MFD NON-COMPLIANCE REPORT # 29303-2

PART NAME: **BRACKET SUPPORT**
PF/SA NO.: **SA-391-555-96 R0**
WORK ORDER NO.: **29303-2 (893053)**
VENDOR **MFD**

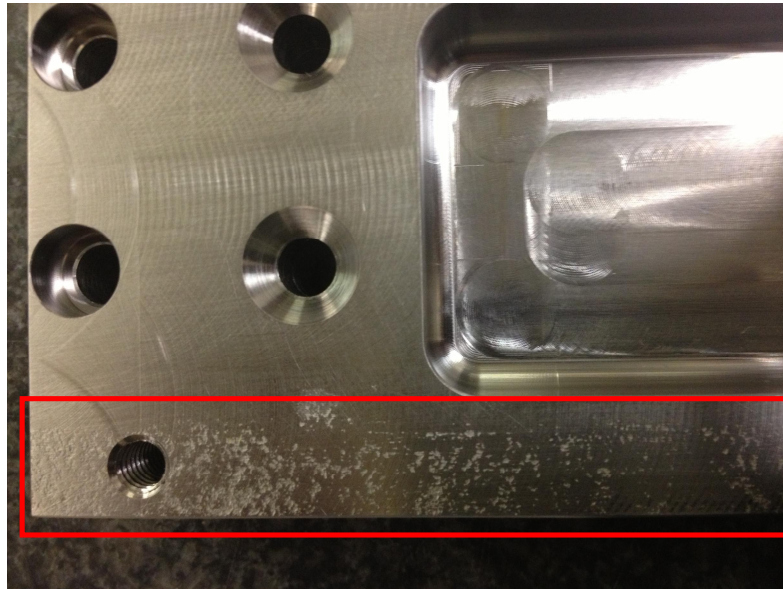
1. ³² ALL SURF ✓ has some areas on Datum -A- that did not clean up. Surface finish measured ~46-50 in that area (see picture below).
